**Subject: Follow up on Rose Quarter Briefing**

We wanted to follow up on the annotated drawing of the proposed facility width since it seemed to cause some consternation.

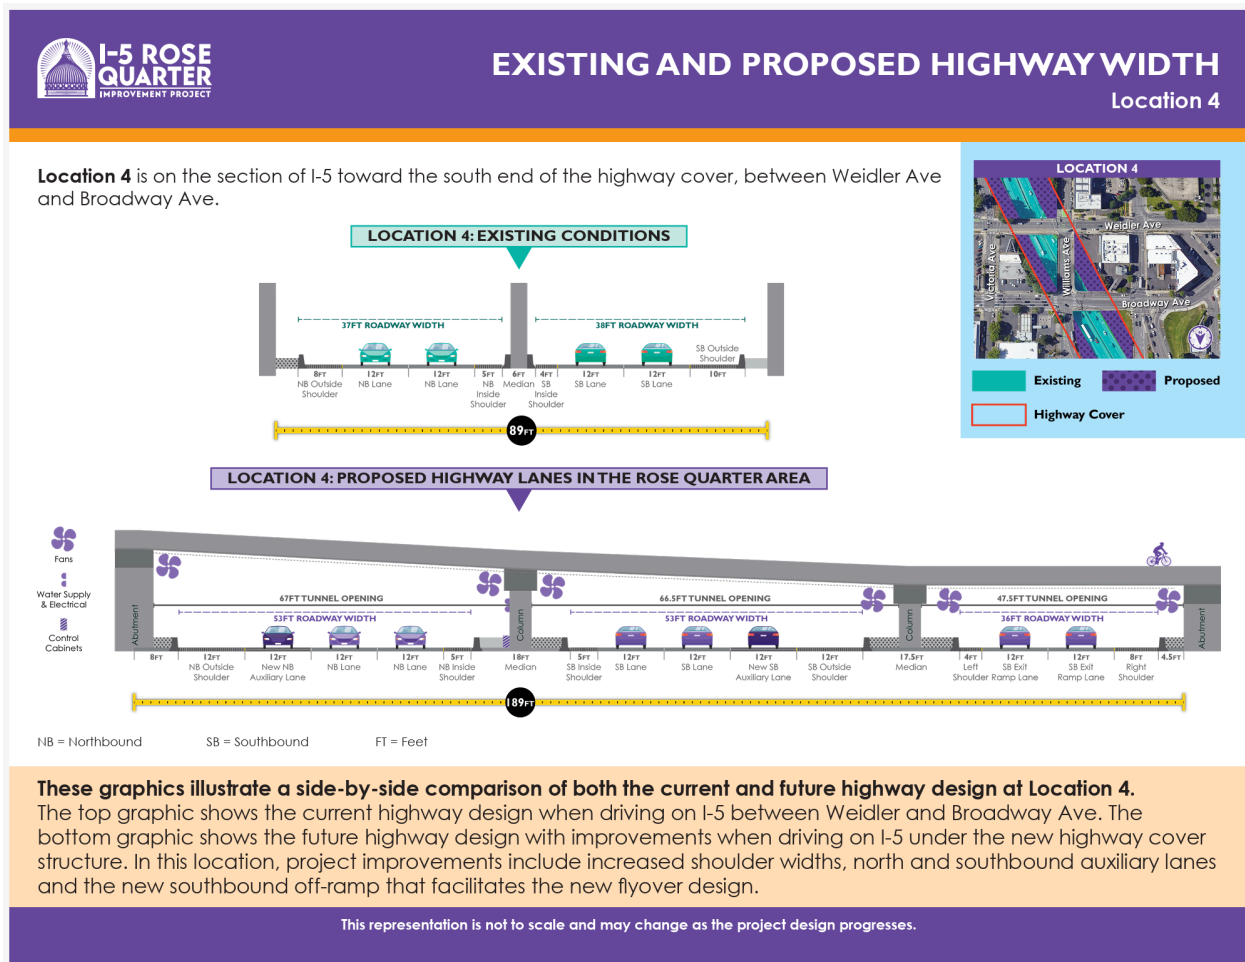
The annotation of potential future possible lane striping is ours, not ODOT's, and we have never tried to represent it as otherwise. We believe that the difference in color and style makes that clear.

We acknowledge that the drawing is two years old. We use it because it clearly shows the project overlaid on the existing cross-section of the highway. In 2023 the proposed new highway cross-section was 162 feet.

The questions about the image obscure the point we're trying to make: a future ODOT could easily restripe to add a lane in each direction.

The current widths are:

- 12 foot outside shoulder
- 3 12 foot travel lanes
- 5 foot inside shoulder

At total of 53 feet of asphalt. This could easily become:

- 5 foot outside shoulder
- 4 11 foot travel lanes (10 foot lanes are not inconceivable)
- 4 foot inside shoulder

ODOT will of course deny that they have any intention to do this. But our point is that the excessive width is causing unneeded expense to taxpayers and the potential additional lane is not accounted for in the environmental review. Historical examples suggest that such restriping might be accorded an exemption from environmental review. **This is of concern to the City of Portland as it could result in additional traffic on City streets, traffic not contemplated in the Portland Transportation System Plan.**
